*STP-209-1(2) Roadway and BHF-209-1(3) Bridge  
Widening of SR 74 From SR 85 to*

*P.I. Nos. 322355 and 322357*

**Value Engineering Study Report**

Preliminary Design Stage

Sht. 14 of 16  
ALTERNATIVE  
DESIGN

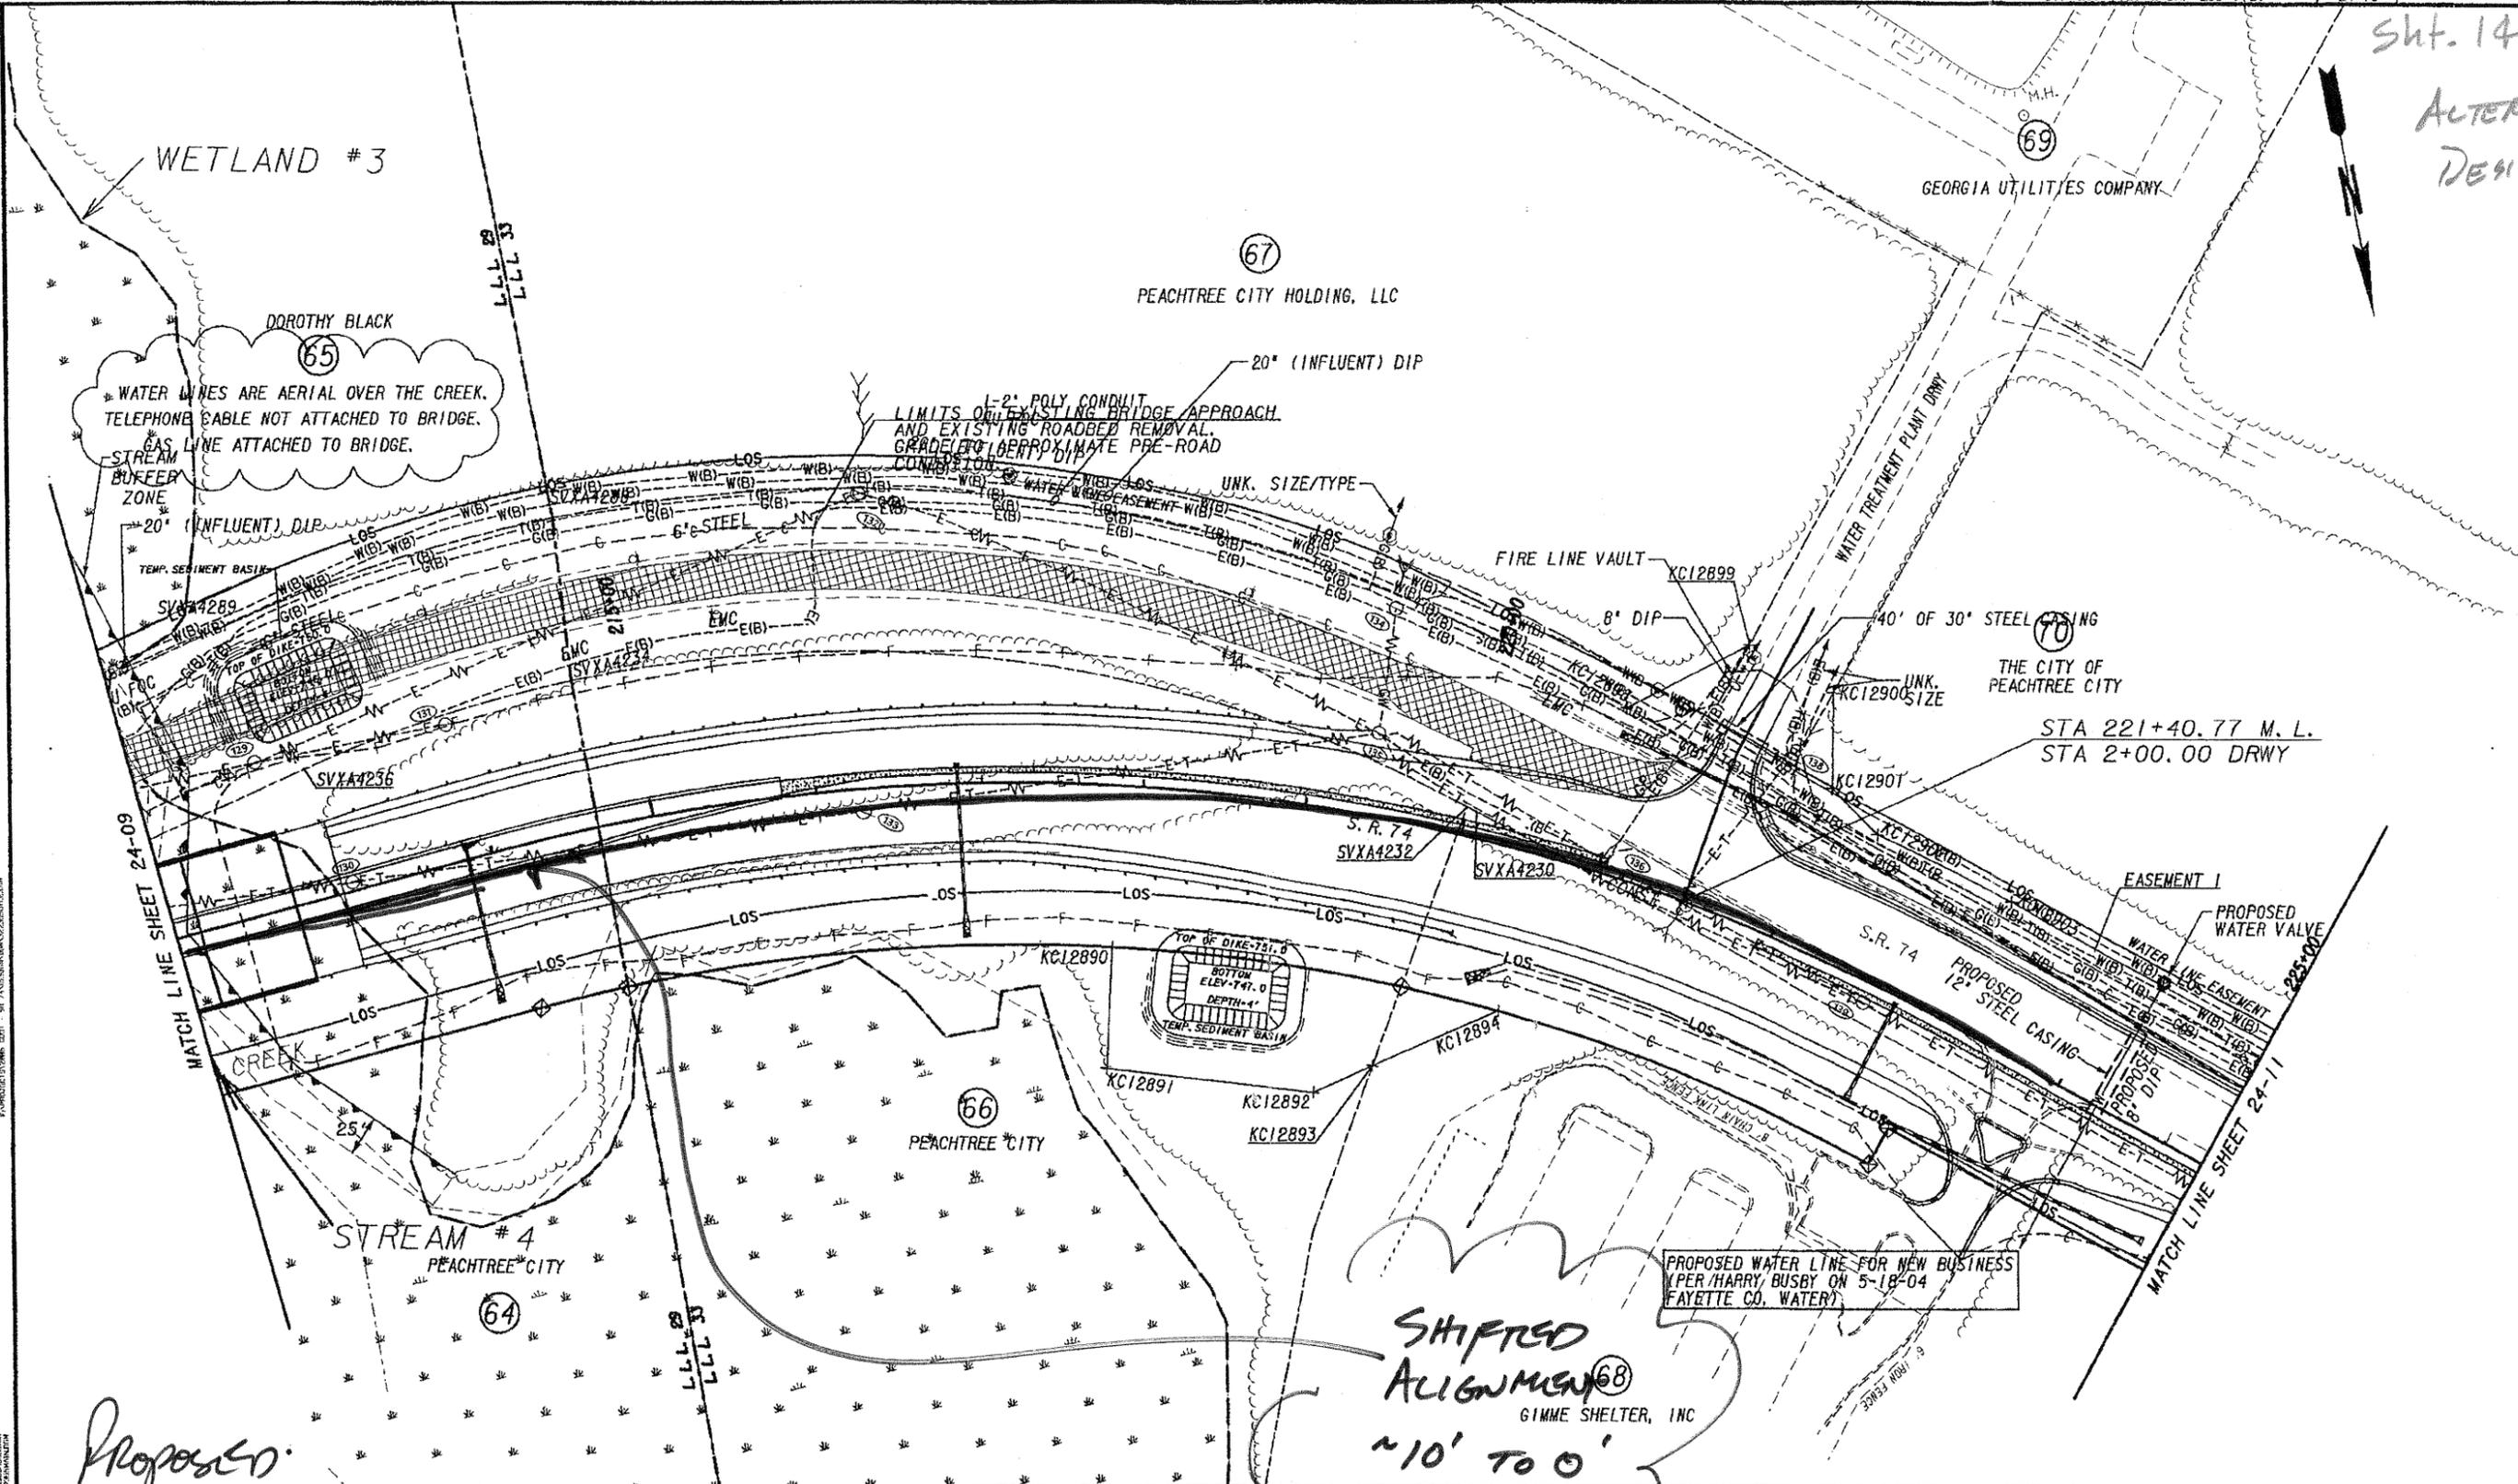
Not up to date  
Propose shifting  
new alignment to miss  
water lines.

ALTERNATIVE  
No. 4  
ORIGINAL  
DESIGN  
SHEET 2 OF 3

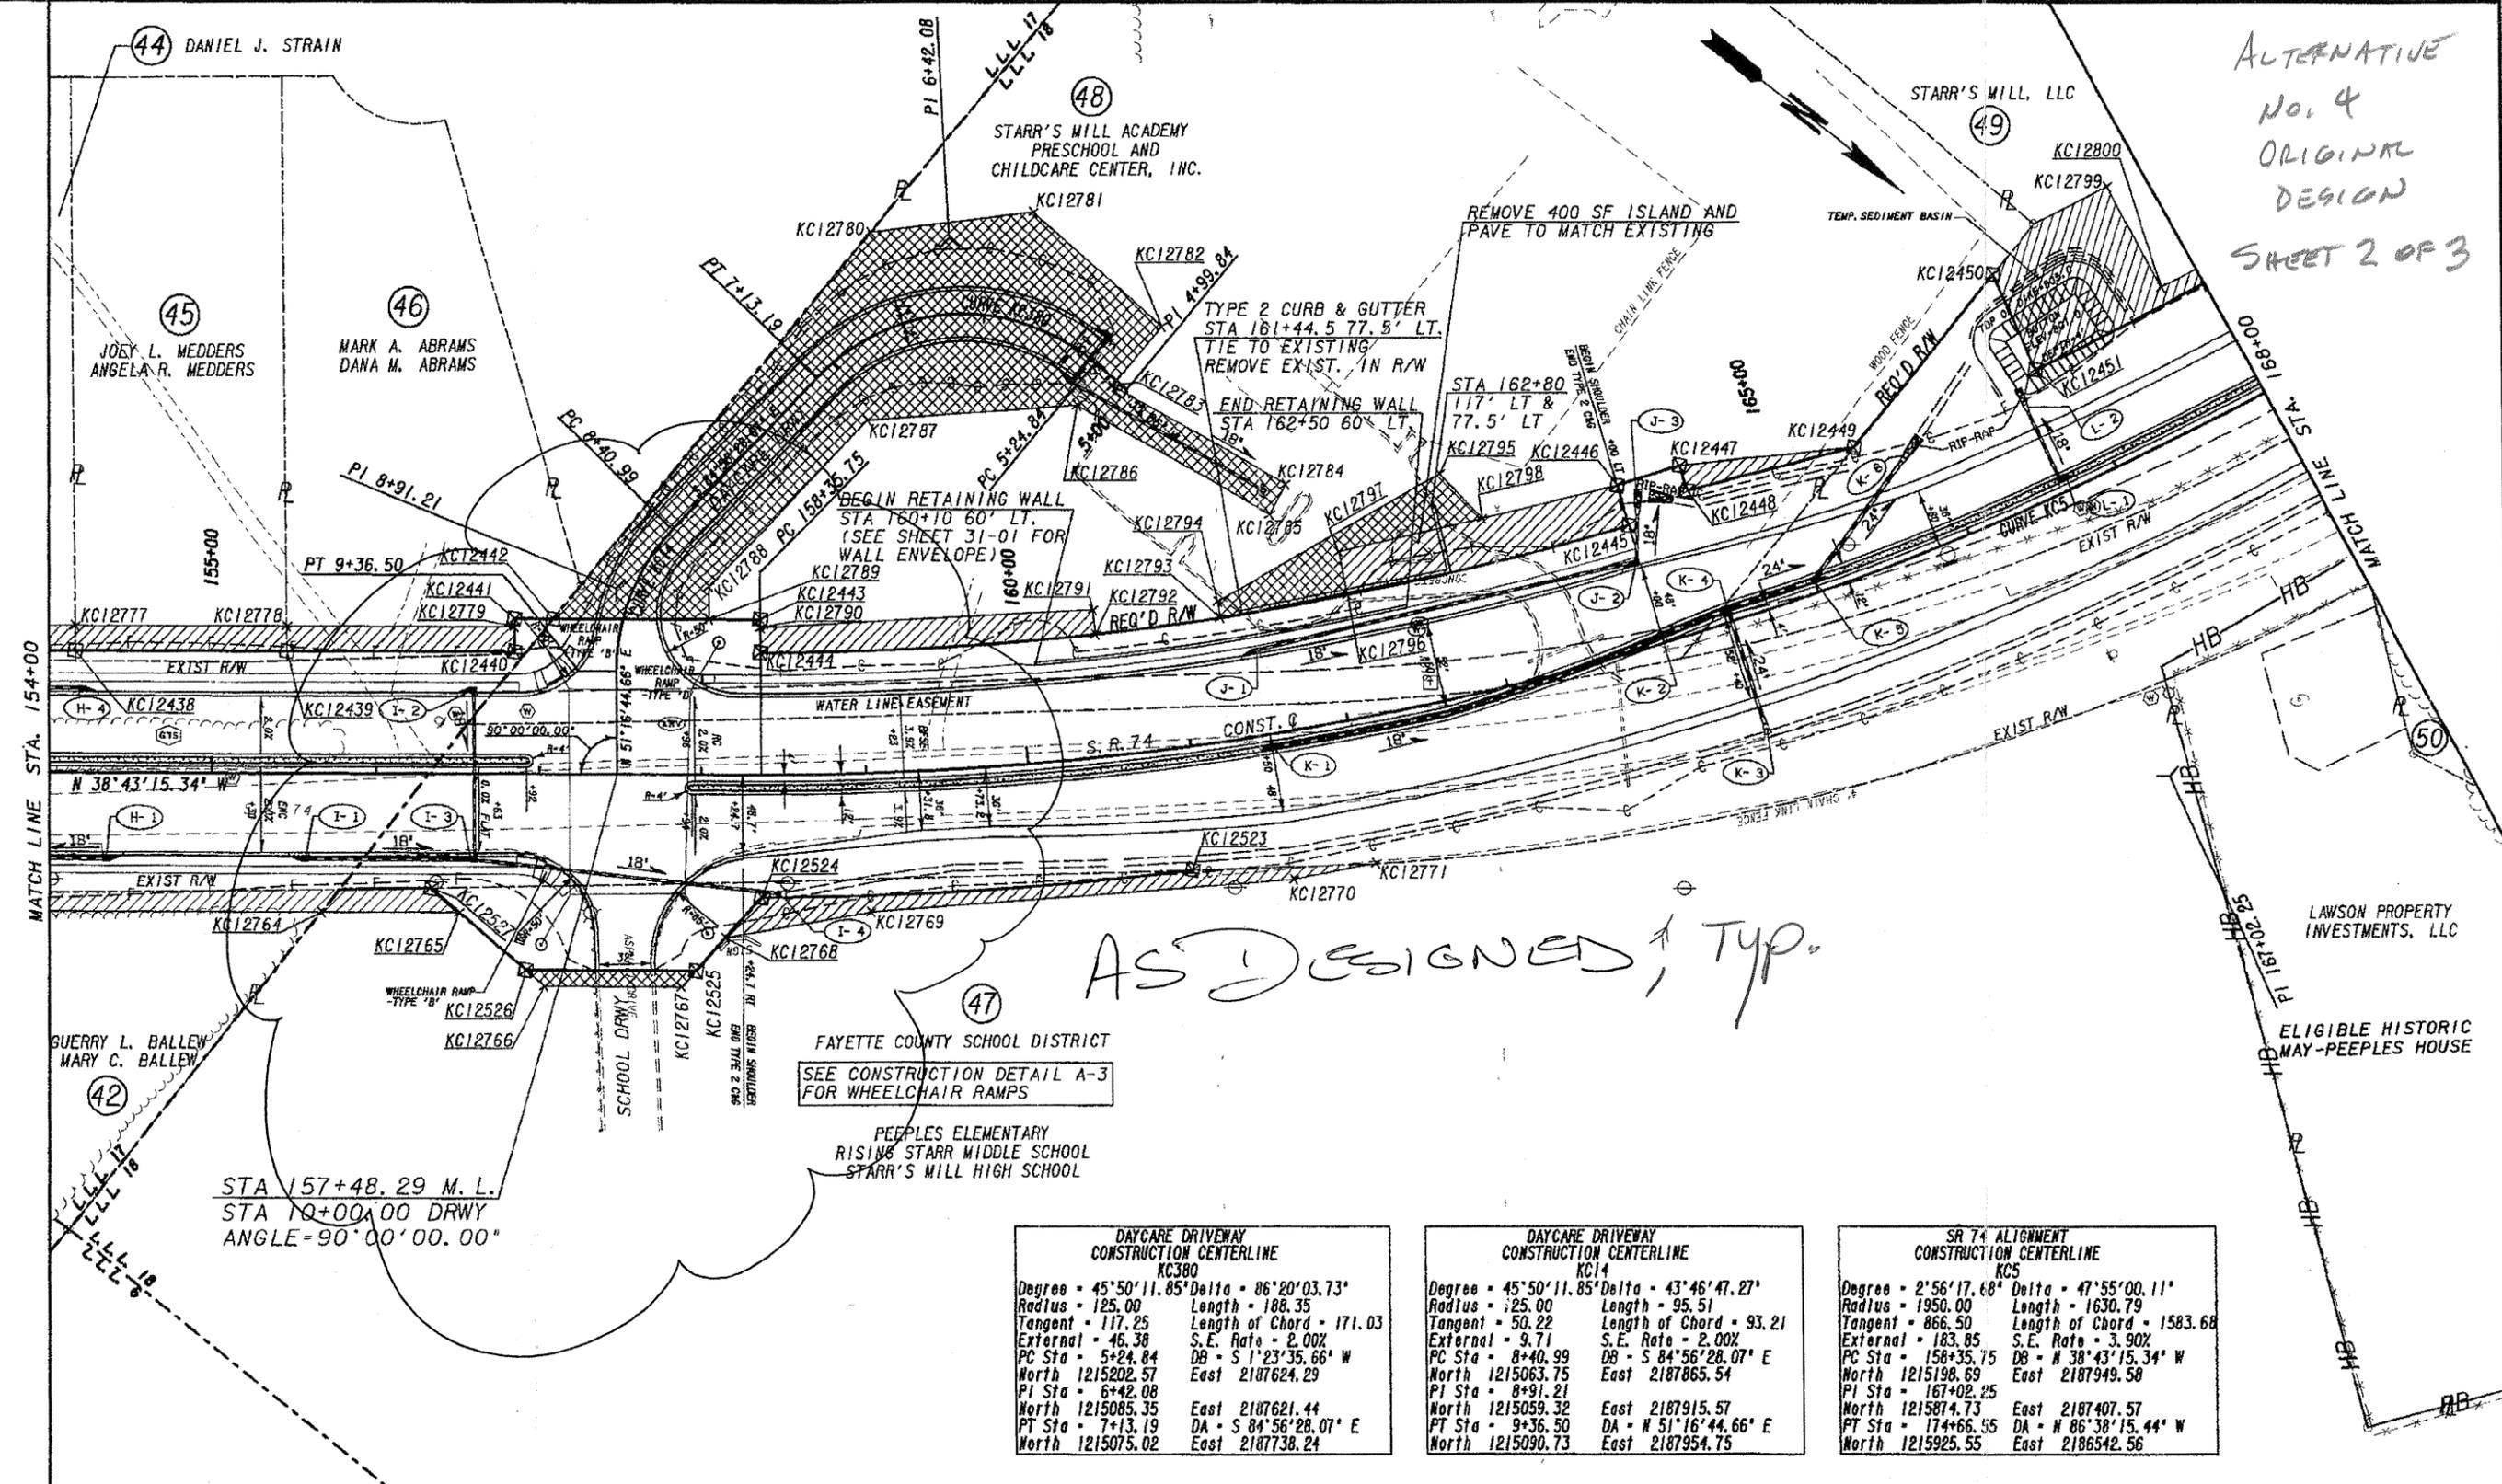
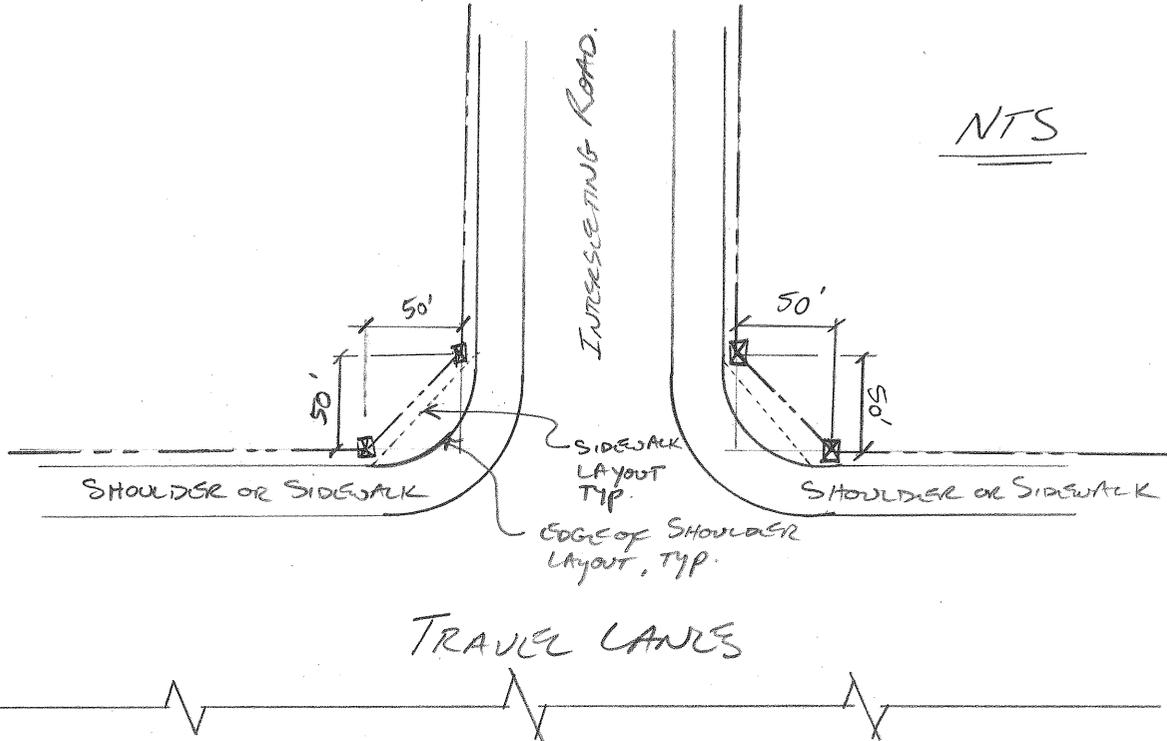
DESCRIPTION: **PROVIDE 50-FT. RIGHT-OF-WAY MITERS AT ALL SIGNALS** SHEET NO.: **1 of 3**
